SLR Project No.: 501.065366.00001

Client Reference No.: ABP-321255-24

RE: Kilsaran Concrete Unlimited Company: Ballinclare Quarry, Co. Wicklow Strategic infrastructure Development Application to An Bord Pleanála Proposed Material Recovery / Recycling Facility and Inert Landfill Response to Request for Further Information

Figure 1
Ballinclare WWTP Arsenic Concentrations of Treated Discharge Water

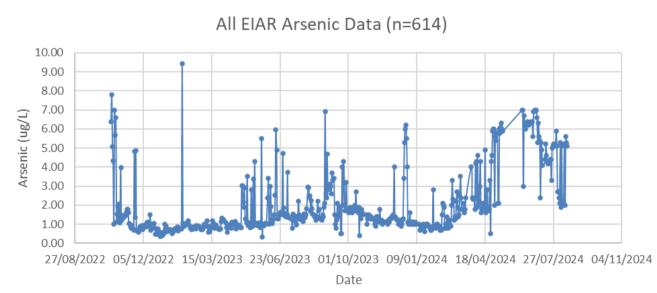
(a) Provision of monitoring results from the inlet and outlet points of the Siltbuster WWTP to demonstrate its effectiveness for reducing arsenic levels

- Available data for quarry sump arsenic concentrations (i.e. equivalent to likely inlet arsenic concentrations to the WWTP). These data are presented in **Table A** below (n = 14, average = 488.03 µg/L); and,
- Outlet/effluent arsenic concentrations (n = 614, average = 2.02 μg/L). Data is plotted as a time series on Figure 1, and as a % exceedance plot as Figure 2. Only

two samples of the 614 samples were above the discharge limit of 7 μ g/L (7.8 ug/l on 20/10/2022, and 9.429 ug/L on 31/01/2023).

Based on the available data the Siltbuster WWTP is assessed to be >99% effective at removing the arsenic load.
